NEW FEATURES

■ 2JZ-GE ENGINE

1. General

151EG39

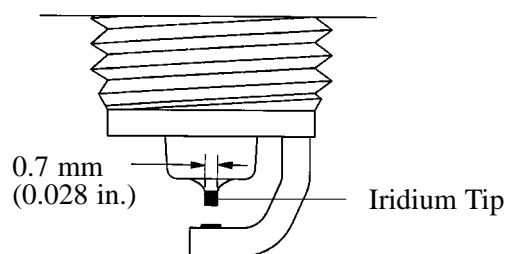
Iridium-tipped spark plugs have been adopted to improve the ignition performance while maintaining the same level of durability of the platinum-tipped spark plugs.

DENSO	SK16R-P11
Plug Gap	1.0 – 1.1 mm (0.0394 – 0.043 in.)
